U.S. ATOMIC ENERGY COMMISSION  
DIRECTORATE OF REGULATORY OPERATIONS  
REGION I

RO Inspection Report No: 50-219/74-02 Docket No: 50-219  
Licensee: Jersey Central Power and Light Company License No: DPR-16  
Madison Avenue at Punch Bowl Road Priority: -  
Morristown, New Jersey Category: C  
Location: Oyster Creek, Forked River, New Jersey

Type of Licensee: GE (BWR) 1930 MW(t)

FIGURE 1

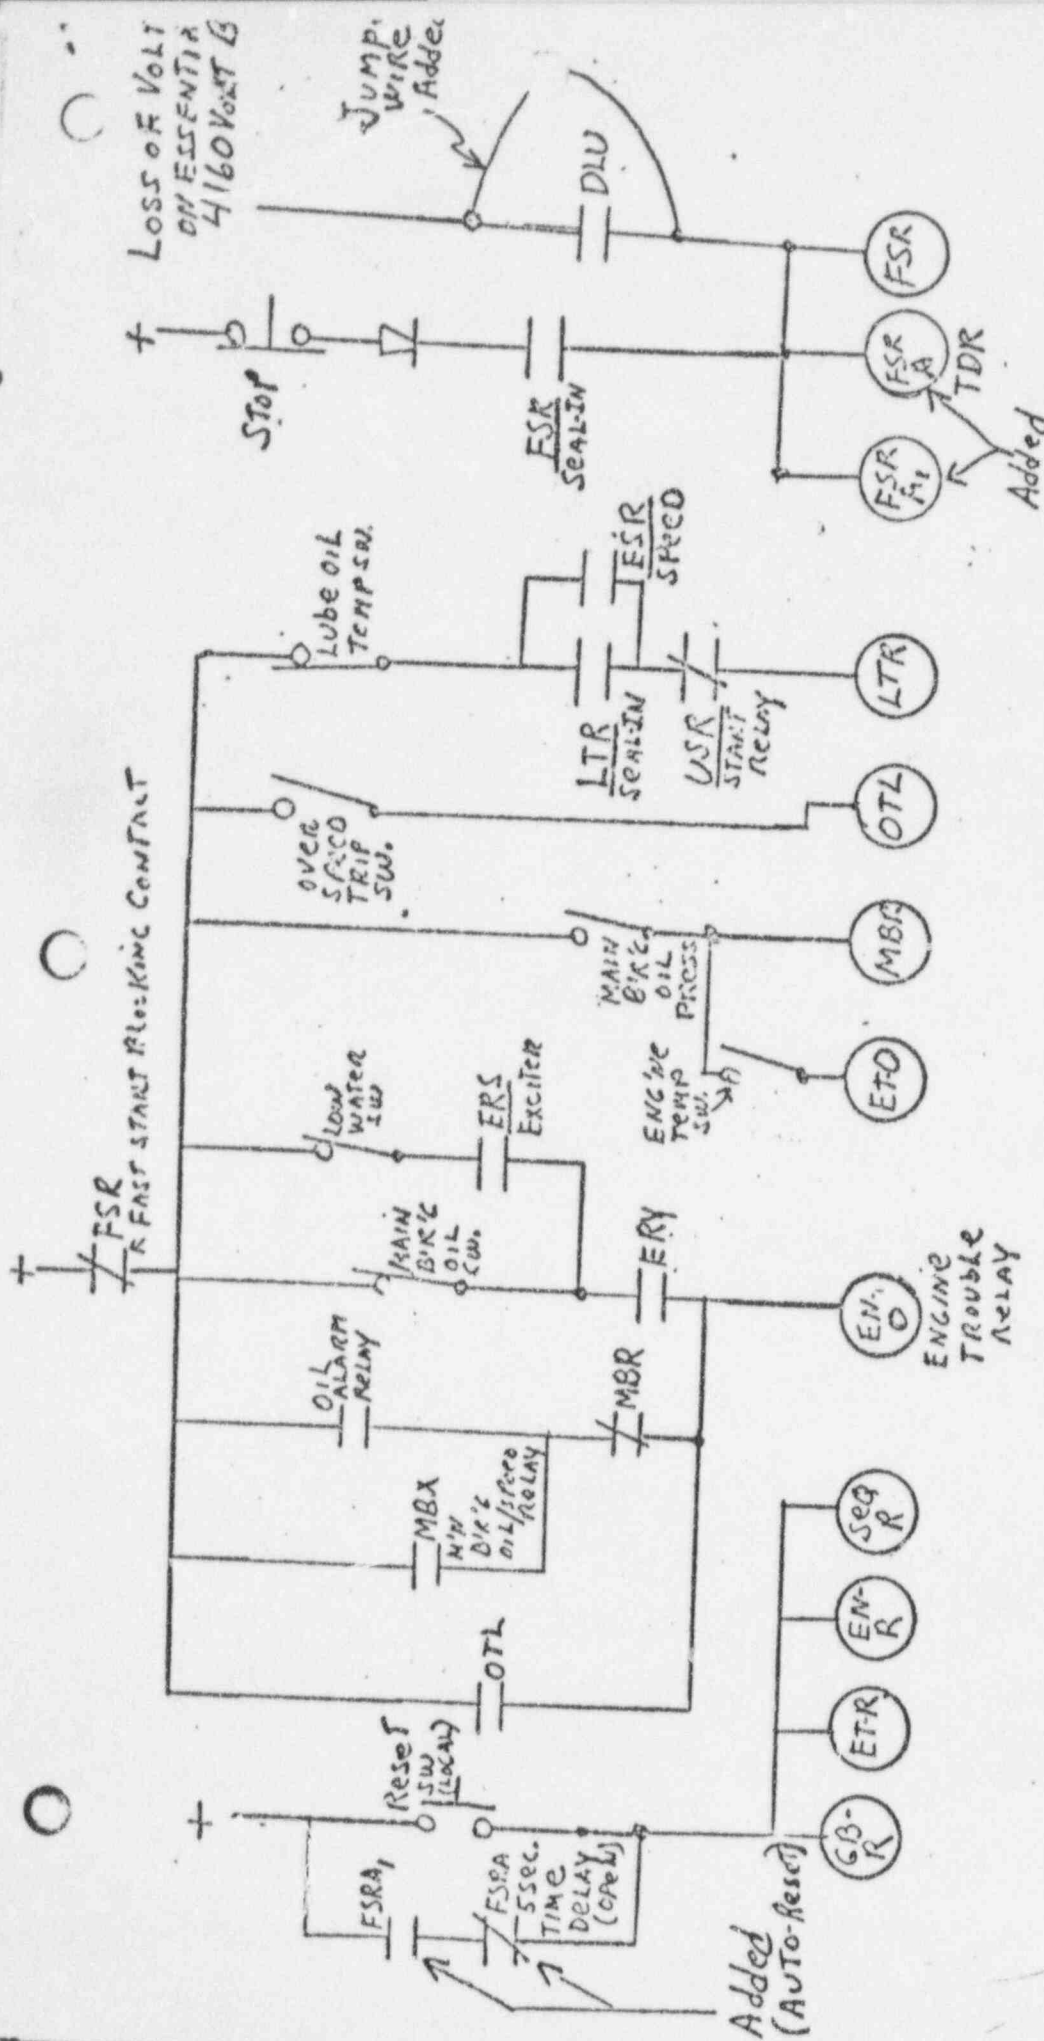
The licensee stated that subsequent to the problem experienced with the diesel generators during the loss of power event, investigation into the matter resulted in modifications of the diesel unit's fast-start, and restart circuitry. These corrective measures are discussed below and are also shown on Figure 1, a simplified schematic of the diesel generator's starting circuitry.

The corrective measures taken by the licensee involved the installation of two relays and a jumper wire. The two "fast-start" auxiliary relays identified as FSRA (time delay) and FSRA<sub>1</sub> (instantaneous), are installed parallel to the existing "fast-start" relay (FSR). The jumper wire is installed around the set of contacts of the "deadline" (DLU) relay. In effect, these modifications now permit the FSR, FSRA, and FSRA<sub>1</sub> relays to be energized simultaneously upon loss of power to any essential 4160 volt bus even though an engine-fault is present. This automatic reset feature is made possible because of the following additional circuit changes:

- a. A set of contacts from each new relay, FSRA and FSRA<sub>1</sub> is now installed in a series parallel circuit arrangement (see Figure 1) around the existing local reset button that is wired in the diesel generator's engine-fault reset circuitry.

- b. The set of contacts from the FSRA relay has a five second time delay "to open" feature while the other set of contacts from the FSAR<sub>1</sub> relay has an instantaneous "to close" feature. This mode of contact operation occurs only when FSRA and FSRA<sub>1</sub> relays are energized.

In summary, the contact operation combined with the circuit arrangement as discussed now provided the licensee with a "built-in" automatic five second reset feature to clear any engine-fault during a diesel generator fast-start situation. There is no longer a need to manually reset the machine to obtain a "fast-start" following a manual shutdown of the unit. It is well to note, however, that the auto-reset feature has no effect during manual operation of the diesel generator. In manual operation, local reset action following unit shutdown is still required.

Our review of the above circuit modifications revealed that these corrective actions have been completed. We also reviewed the licensee's abnormal occurrence report, and his test procedures of the diesel unit following the above modifications, and no items of discrepancy were noted.
